CCB# 6061.001
Pre and Post Change Summary
PCN #: DSNO-27BXFC465

Pre and Post Change Summary – Tray

ASE9

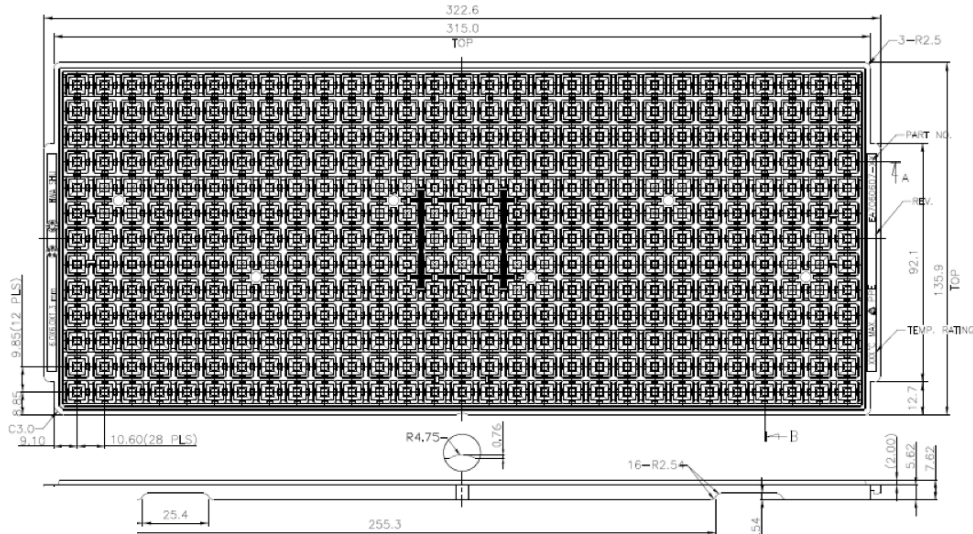
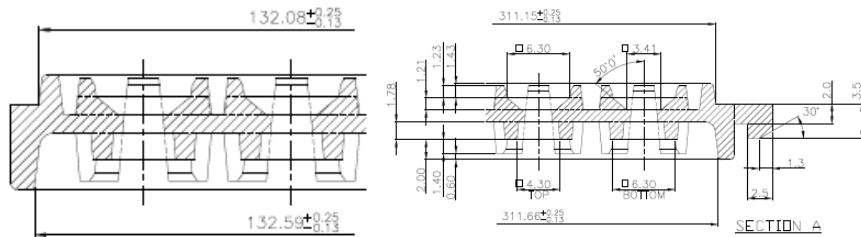
Plant	Tray Color	Tray Dimension
ASE9	Black	315mm X 135.9mm X 7.62mm
MPHL	Black	315mm X 135.9mm X 7.62mm
